Dear Referee,

We would like to thank you for your professional and constructive comments concerning our manuscript entitled "Assessment of the physical vulnerability of buildings affected by slow-moving landslides". These comments are all valuable and helpful for revising and improving our manuscript. We have seriously considered and provided our point-by-point responses, which are listed below.

Fig.3 The simple beam with its foundation affected by landslide thrust.

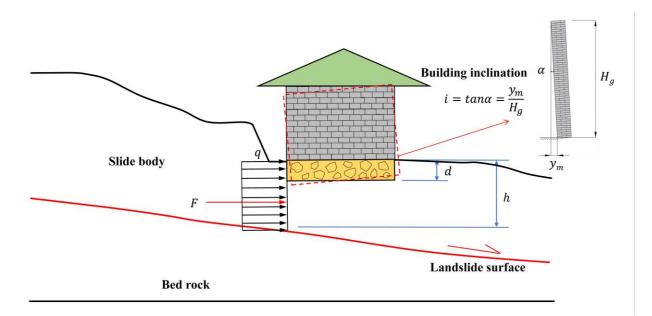
(1) In Section 2.2.1 the Authors recall the equivalent elastic beam – originally introduced by Burland and Wroth (1974) to define a damageability criterion – in order to compute the maximum deflection exhibited by the same beam under a uniform load whose modulus equals q. In Figure 2 this uniform load acts horizontally, in correspondence of the lateral surface of the building's foundation affected by the landslide; whereas in Figure 3 the uniform load is applied vertically to the elastic beam. Accordingly, it is not clear in which direction the maximum deflection develops. Furthermore, symbols adopted in Figures 2 and 3 to denote the geometrical characteristics of the building's foundation are not internally consistent. Could the Authors better explain?

Response: thank you very much for the comment. In Figure 3, we actually try to express the uniform load applied horizontally, so sorry for the confusing. We plan to revise the figure 3 as follows.

Fig. 2. Schematic diagram of landslide thrust action on a building.

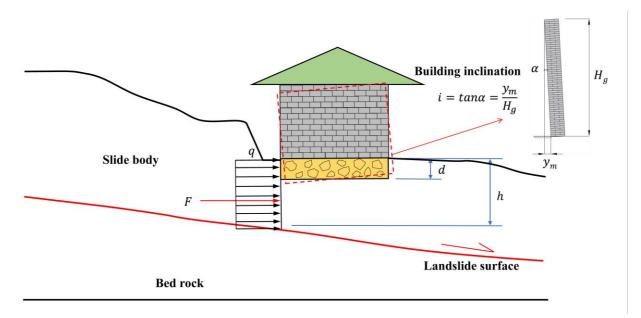
(2) In the same Section 2.2.1 the concept of "inclination" of a building is introduced. Does this inclination corresponds to the "rotation" or "slope" (i.e. the change in gradient of a line joining two reference points of the foundation base) or to the "tilt" (describing the rigid body rotation of the whole superstructure or a well-defined part of it) defined by Burland and Wroth (1974)? Or does it refer to another well-defined parameter? Please clarify. I also suggest to associate the Eq. (9) – used to express mathematically the concept of inclination – with a Figure helpful to better understand the meaning of symbols adopted in Eq. (9), including the angle alpha.

Response: thank you very much for the suggestion. The concept of "inclination" in our manuscript is that the ratio of the difference y_m (between the top and bottom of the building) to the height H_g of the building. In some references, such as researches by Li (2010), this concept is used for "inclination". We inserted a figure in Fig.2 to better understand the meaning of symbols adopted in Eq. (9) as follow.
